NUCLEAR REGULATORY COMMISSION

Title: Advisory Committee on Reactor Safeguards
ABWR Subcommittee Meeting

Date: Wednesday, April 24, 2013

FSAR Figure 2.4S.4-13c:
Comparison of BREACH and
FLDWAV Outflow Hydrographs

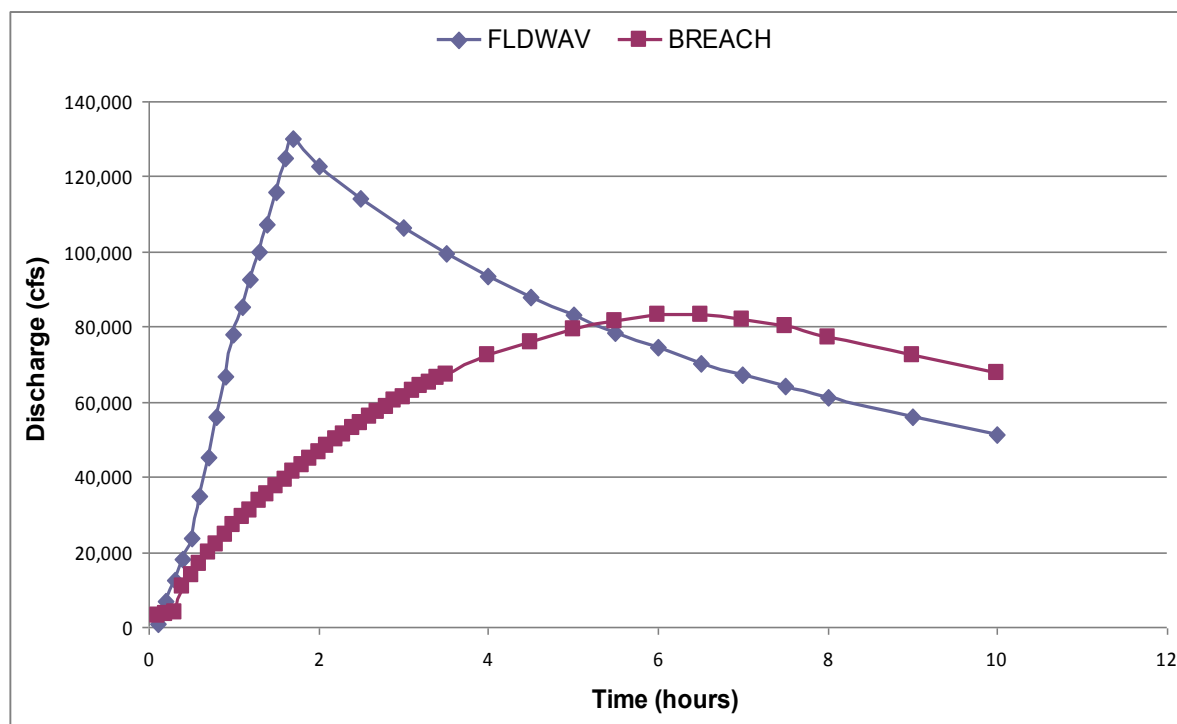
How does MCR breach width derived from Froehlich's equation used in the FLDWAV model compare with value used in confirmatory BREACH Model?

FLDWAV (STP COLA Model using Froehlich width and MLM time)
compared to
BREACH Model (independent confirmatory analysis)

➤ Non-concurrence Issues:

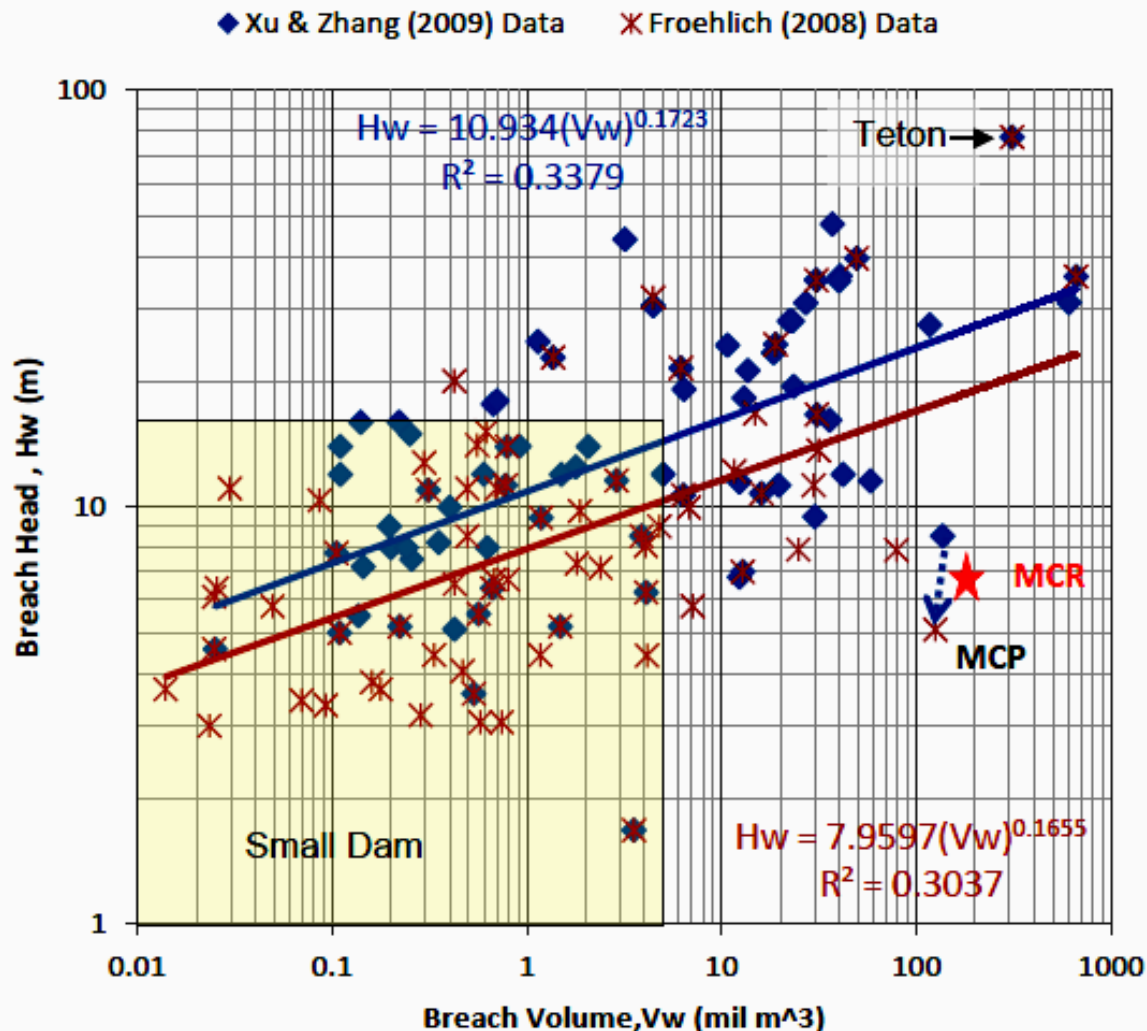
- STP's breach width estimate is not conservative compared to other similar cases:

- ✓ 2000 ft for STP Units 1&2
- ✓ 2034 ft for Victoria ESP
- ✓ 4757 ft for STP FSAR v. 0&1
- ✓ 600 ft on the Martin Cooling Pond breach.

- Other government guides (USBR, USACE, etc.) recommend to '**use all equations, then make an engineering judgment.**' However, STP did not use the MLM breach width equation as well as many breach peak flow equations, resulting in non-conservative parameter estimates (see my re-analysis).

The Staff Used an Unrealistically Small Tailwater Section

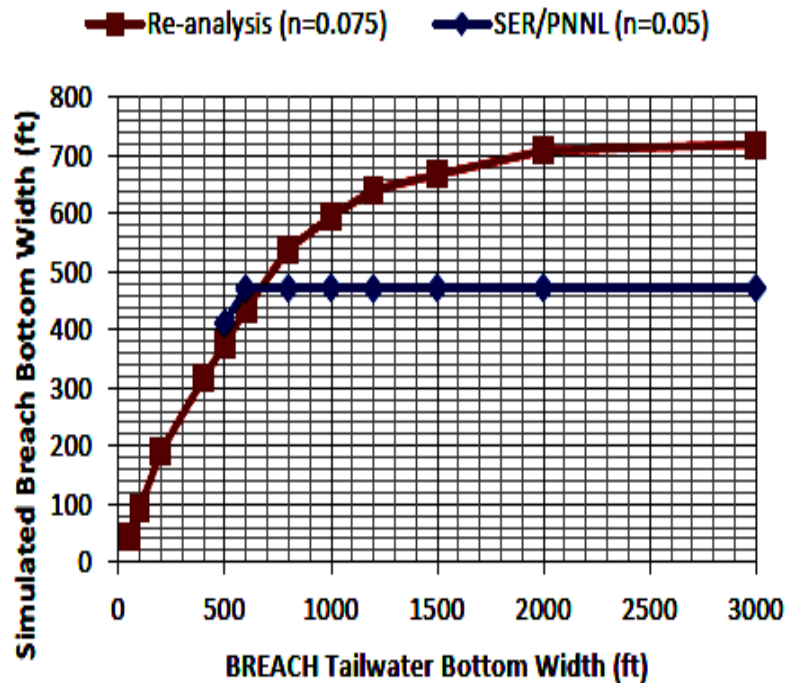
- The staff used an **unrealistically small** tailwater section (width of 600 ft) compared to the anticipated breach width (The same is true in FSAR Table 2.4.4-6b). Then the staff concluded that tailwater section is not critical in breach and that a small tailwater section is realistic.

- I disagree. The MCR breach tailwater zone is wide (>1 mile) overland plain with mild upslope to the North (4 ft to 1 mi), so that the tailwater spreads quickly and widely to the lateral directions - **A wide tailwater section is realistic.**
- My re-analysis shows that small tailwater section produces high tailwater level at the beginning of breach, resulting in reducing breach head and resulting breach width significantly. My sensitivity analysis also shows that tailwater section is very critical in breach.

(Staff: 600 ft at bottom, 2800 ft at top; Re-Analysis: 3000 ft)

Sensitivity of Two Breach Parameters (n-value and Tailwater Section)

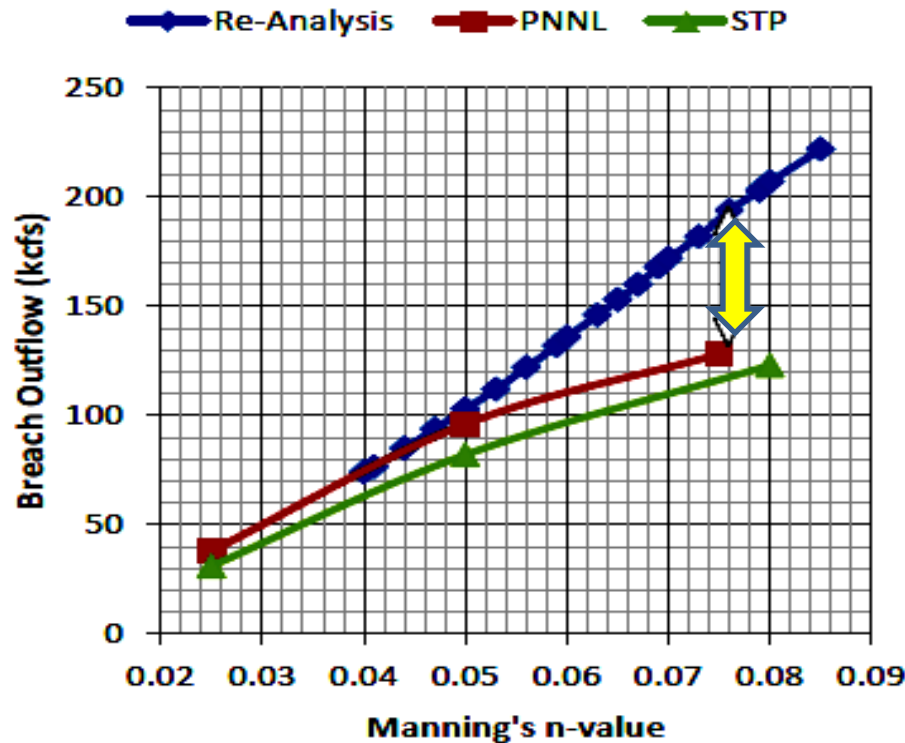
- The staff/PNNL selected $n=0.075$. However, they performed a tailwater section sensitivity analysis with $n=0.05$, then concluded that the tailwater section is not a limiting factor. (SER p. 51) – This conclusion is incorrect as my re-analysis shows that tailwater section is very sensitive in breach.
- The staff obtained peak flow of 130 kcfs using BREACH with $n=0.075$ and a small tailwater section, then concluded that STP's breach estimate is acceptable – The model is flawed.
- In my re-analysis, I used a width of 3000 ft, but a tailwater width greater than 2000 ft is acceptable (see Ahn, 2012a).

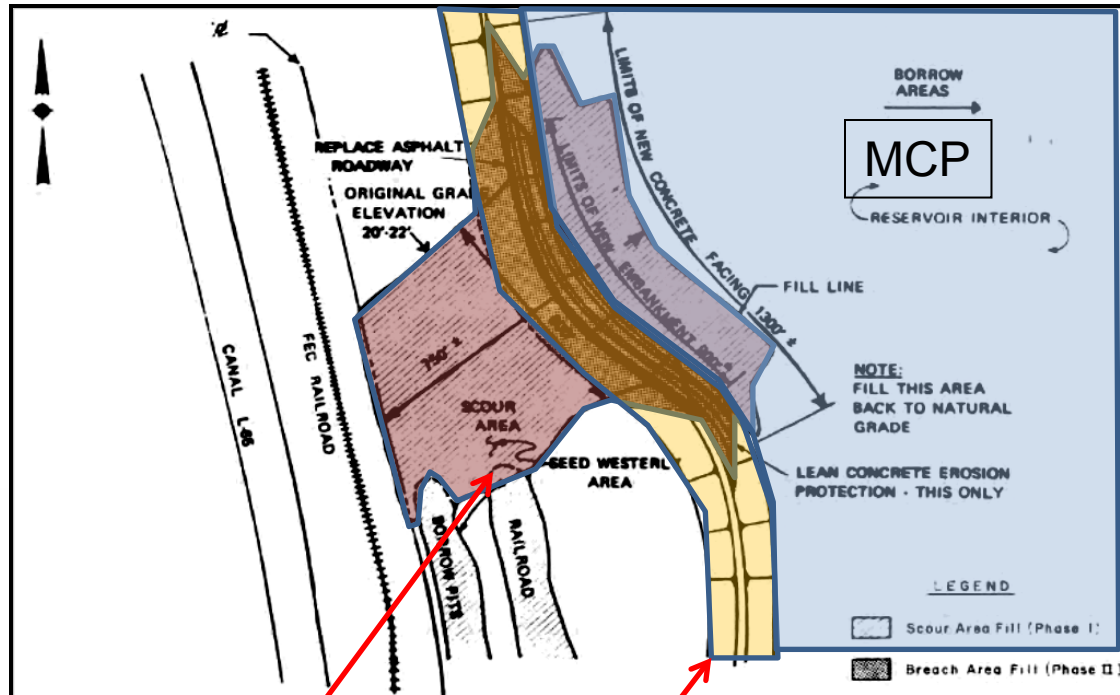
- The differences in outflows are due to width of the tailwater section and soil properties.

- It is clear from the figure that the staff underestimated breach outflows by using a small tailwater section.

#3 Maximum Groundwater Level

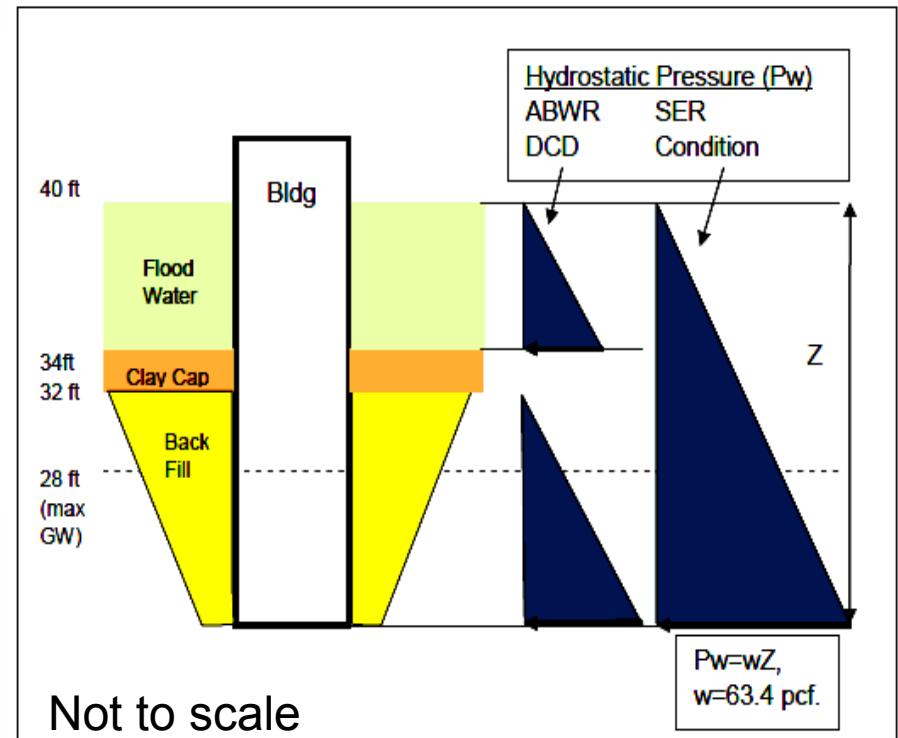
Issue: The departure of the maximum groundwater level (ABWR DCD Tier 1 Site Parameters) is not addressed in subsequent structural analyses.

B1 Postulating Scour Hole in Re-analysis

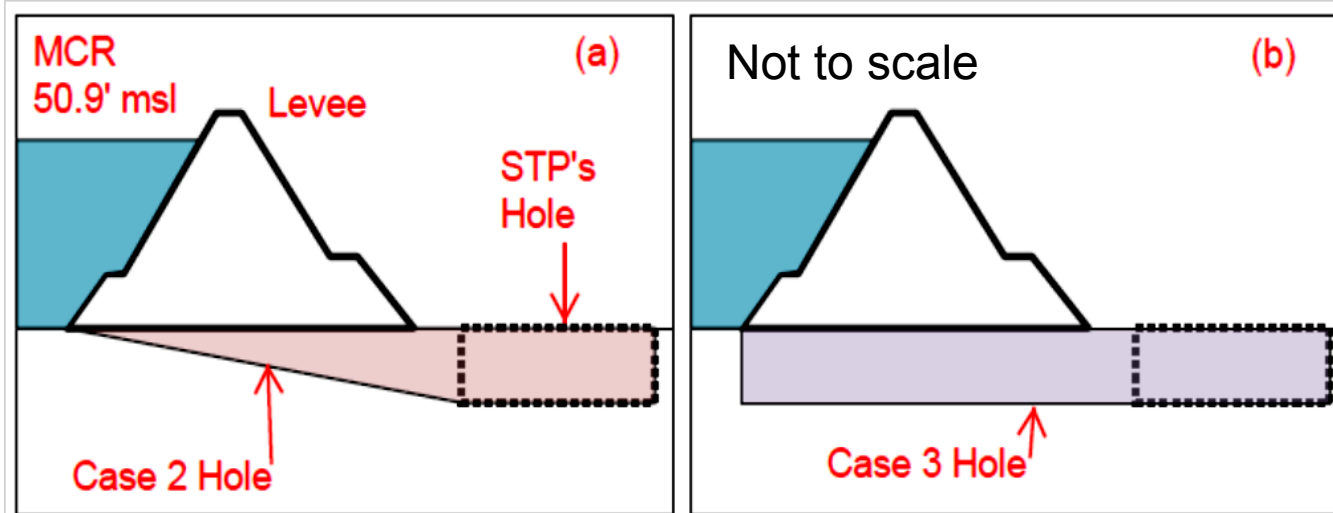
- SFWMD (1980) reports that large cement blocks (size of 6'x6'x6") were found on the bottom of the MCP breach – This is similar to a boulder channel, and thus for MCR breach.
- Substantial contraction and expansion of breach flow occur before and after water passing the breach zone, resulting in a significant head loss.
- The staff also got a tailwater n-value of 0.056 using the same Chow method,

- STP postulated a scour hole ($W=380$ ft, $L=203$ ft, $D=20$ ft) at the downstream toe of the embankment, but not on the levee foundation – **I disagree. Scouring of the foundation is highly likely.**
- Re-analysis postulated and tested three scouring scenarios: hole depths of 0ft, 10 ft, and 20 ft below the levee. The corresponding peak breach outflows are 194 kcfs, 269 kcfs, and 267 kcfs, respectively.

B1 My Comments on Dr. Patev's Review of MCR Breach

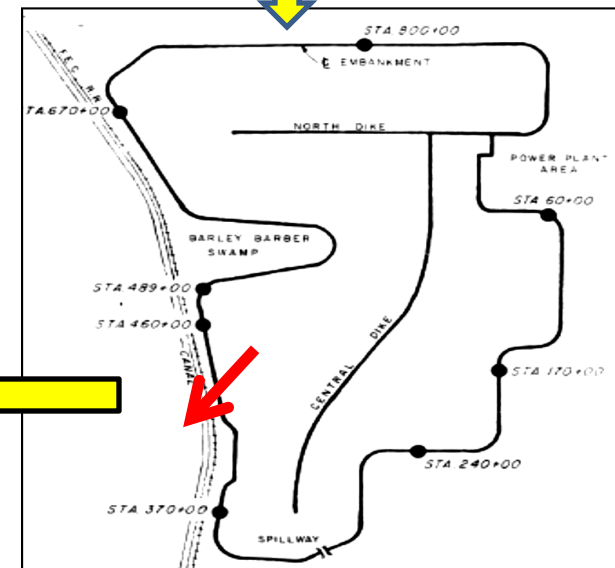
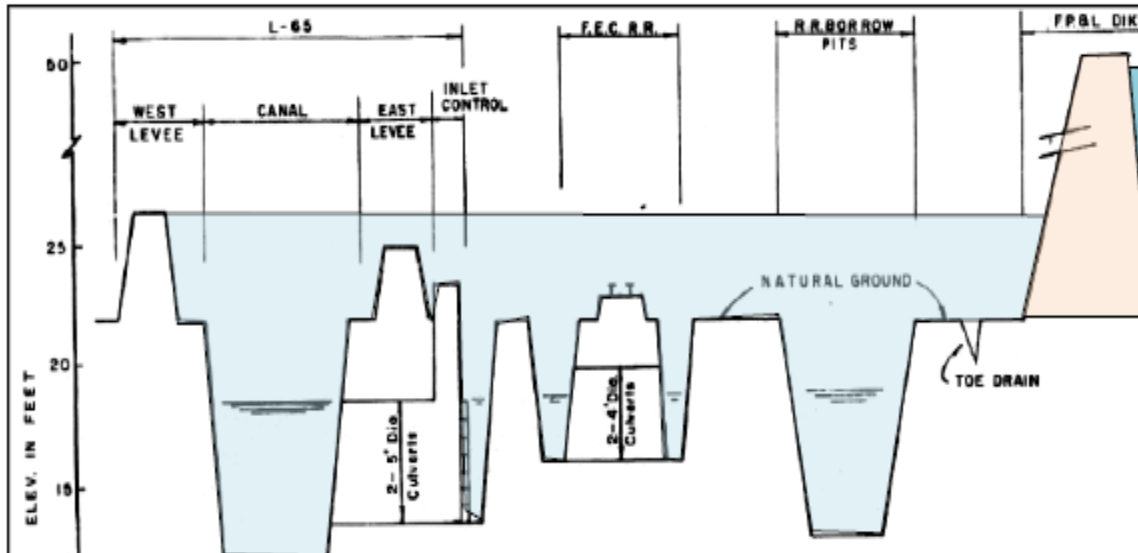
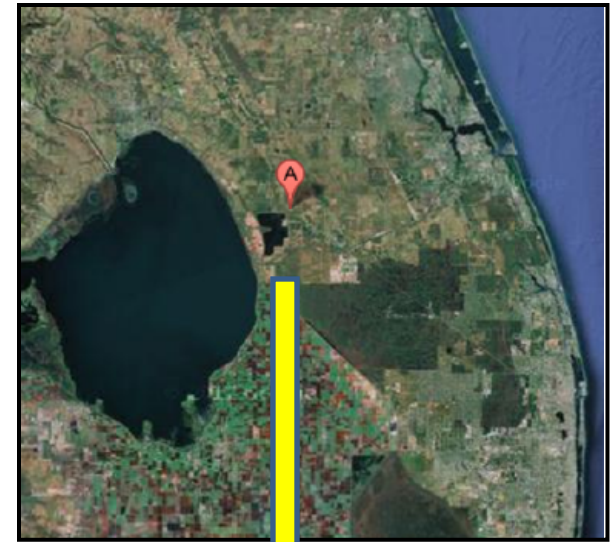
Dr. Patev focused his review on the geotechnical aspects of MCR breach, then concluded that a wide breach with scour hole is highly unlikely. However many of his assertions are speculative or not factual as:

- Seepage failure is highly unlikely because of compacted silt-clay, seepage control system (e.g., relief wells, sand chimney, berms, etc.), and low permeability (10^{-5} cm/sec). Foundation materials consist with two different clays. – **Comment: He failed to recognize sand layers in foundation, through which seepage has been observed.**
